**SOLICITATION AMENDMENT  
MODIFICATION DE L'INVITATION**

<b>Title - Sujet</b> Purchase of Shelving & Installation	
<b>Solicitation No. - N° de l'invitation</b> 5X001-170733/A	<b>Amendment No. - N° modif.</b> 002
<b>Client Reference No. - N° de référence du client</b> 5X001-170733	<b>Date</b> 2017-11-20
<b>GETS Reference No. - N° de référence de SEAG</b> PW-\$\$HN-465-73690	
<b>File No. - N° de dossier</b> hn465.5X001-170733	<b>CCC No./N° CCC - FMS No./N° VME</b>
<b>Solicitation Closes - L'invitation prend fin</b> <b>at - à 02:00 PM</b> <b>on - le 2017-12-18</b>	
<b>Time Zone</b> Fuseau horaire Eastern Standard Time EST	
<b>F.O.B. - F.A.B.</b> <b>Plant-Usine:</b> <input type="checkbox"/> <b>Destination:</b> <input checked="" type="checkbox"/> <b>Other-Autre:</b> <input type="checkbox"/>	
<b>Address Enquiries to: - Adresser toutes questions à:</b> Nadeau, Alexandra	<b>Buyer Id - Id de l'acheteur</b> hn465
<b>Telephone No. - N° de téléphone</b> (819) 420-2859 ( )	<b>FAX No. - N° de FAX</b> (819) 953-4944

This amendment 002 is being raised to address questions submitted by potential bidders and to modify the drawings from Annex A – Statement of Work;

## Floor plan - racking to be installed (Phase I) –Top view

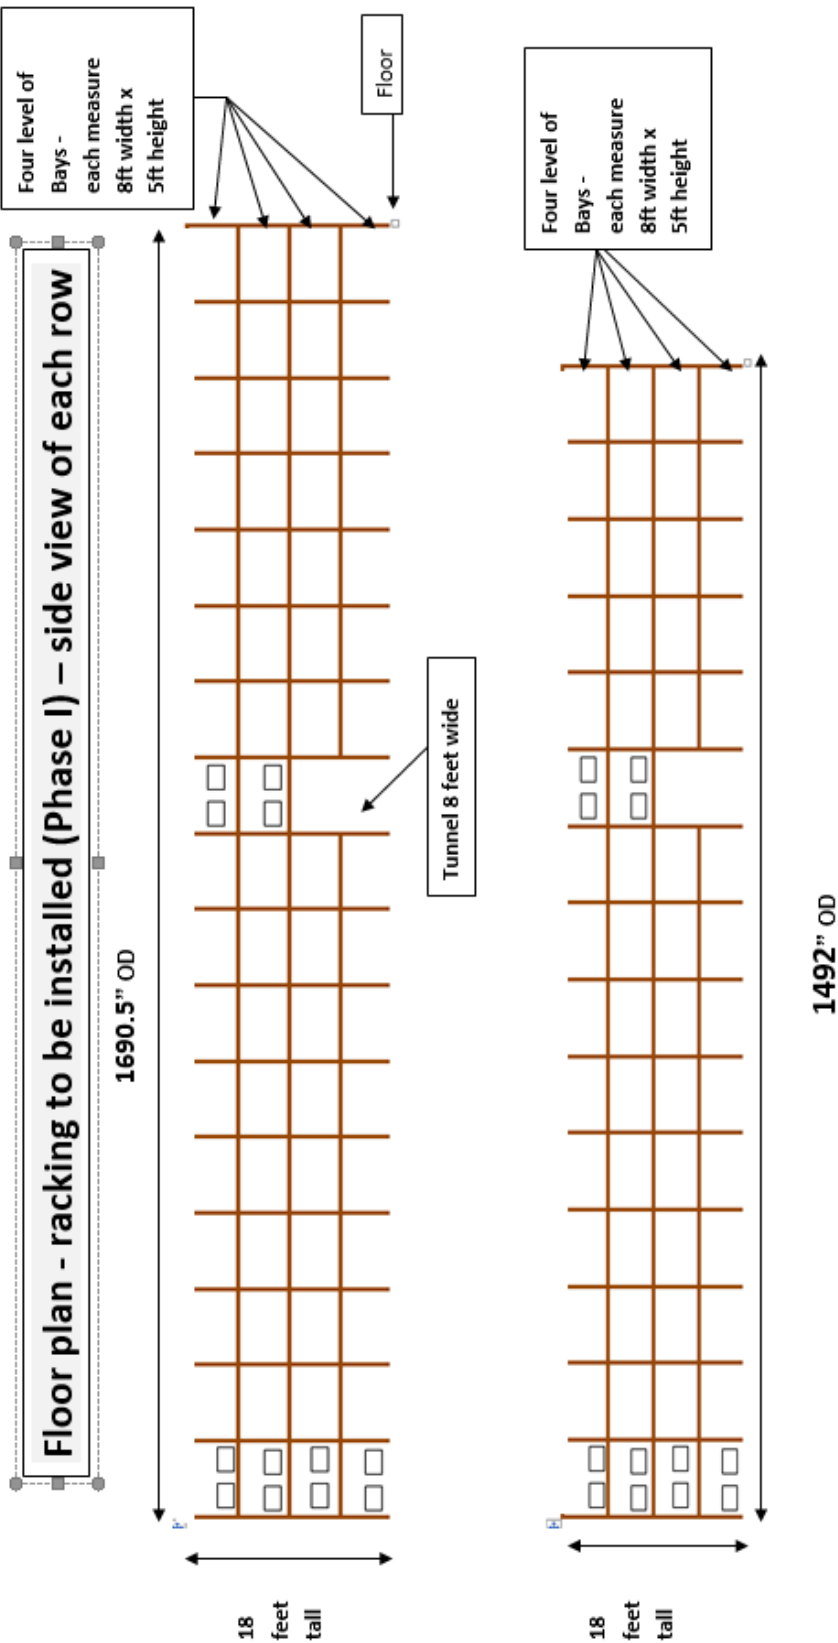
Q2) The Phase 1 drawing and descriptions are contradictory. The drawing illustrates rows of 34 bays and 30 bays whereas the description is requesting 50 bays and 44 bays. Which is correct?

Q12) After reviewing the drawing and the verbiage within the tender package, can we clarify the terminology used to make sure we have the same quantity of material expected? We assume the following – each bay consists of ground plus three beam levels, allowing for 8 pallet locations per bay and the tunnel bay will allow for 4 pallet locations. If so, you require (as in the drawing) Phase 1 – 6 rows of 16 bays plus 1 tunnel bay and 2 rows with 14 bays plus 1 tunnel?

***A2) We amended the drawing and the descriptions to ensure we are clear on the total number of bays in each row of racking and to ensure we are consistent with our terminology. We added a side view of the racking. Please refer to the amended Phase I and Phase II floor plan drawings.***

**A12) We amended the drawing and the descriptions to ensure we are clear on the total number of bays in each row of racking and to ensure we are consistent with our terminology. We added a side view of the racking. Please refer to the amended Phase I and Phase II floor plan drawings.**

- 6 rows of racking, each row consists of 66 bays and measure 1690.5" OD.
- 2 rows of racking, each row consists of 58 bays and measure 1492" OD.
- Each row of racking consists of four levels of bays except for the tunnels that consist of two levels of bays.
- Each row of racking is 18 feet tall.
- Each bay measure 8ft width x 5ft height
- Each row of racking has an 8ft tunnel (size of a bay) for Forklift passage.
- 1.5 per frame in back-to-back row - 12" ROW SPACERS – GALVANIZED.
- Each two back-to-back rows are separated by a distance of 10 feet.

## Floor plan - racking to be installed (Phase II) - Top view

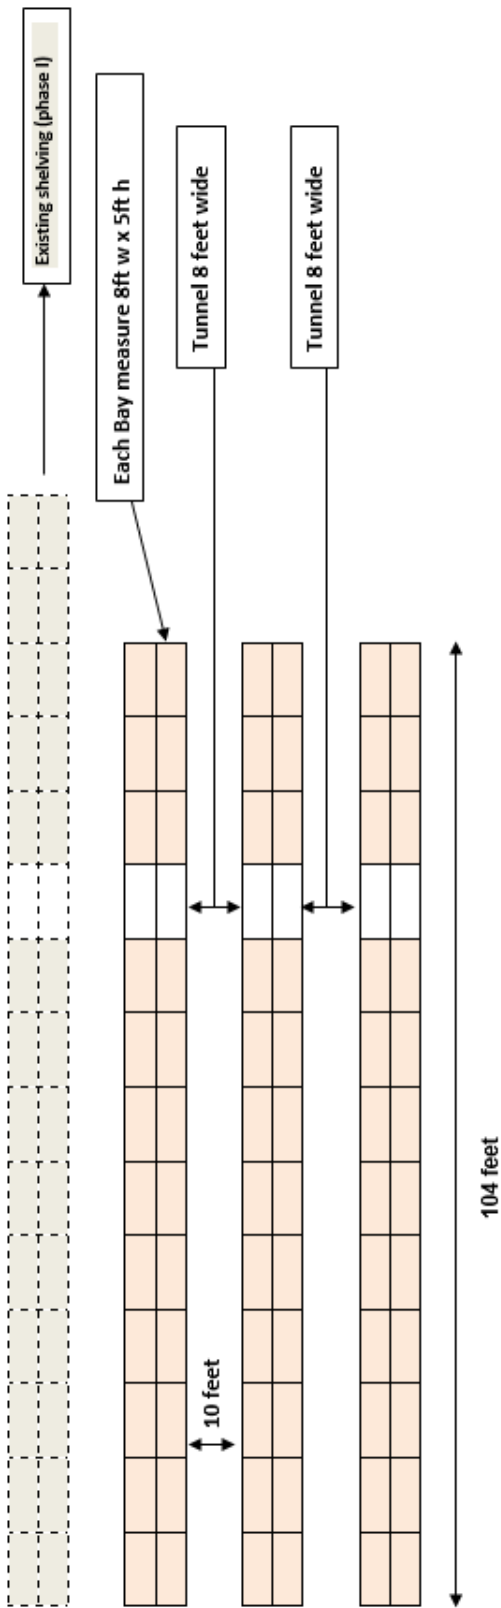
Q3) The Phase 2 drawing and descriptions are contradictory. The drawing illustrates rows of 26 bays whereas the description is requesting 38 bays. Which is correct?

***A3) We amended the drawing and the descriptions to ensure we are clear on the total number of bays in each row of racking and to ensure we are consistent with our terminology. We added a side view of the racking. Please refer to the amended Phase I and Phase II floor plan drawings.***

- Each row consists of 50 bays and measures 104 feet.
- Each row of racking consists of four levels of bays except for the tunnels that consist of two levels of bays.
- Each row of racking is 18 feet tall.
- Each Bay measure 8 feet width x 5 feet height
- Each row of racking has an 8ft tunnel (size of a bay) for Forklift passage.
- 1.5 per frame in back-to-back row - 12" ROW SPACERS – GALVANIZED.
- Each two back-to-back rows are separated by a distance of 10 feet.
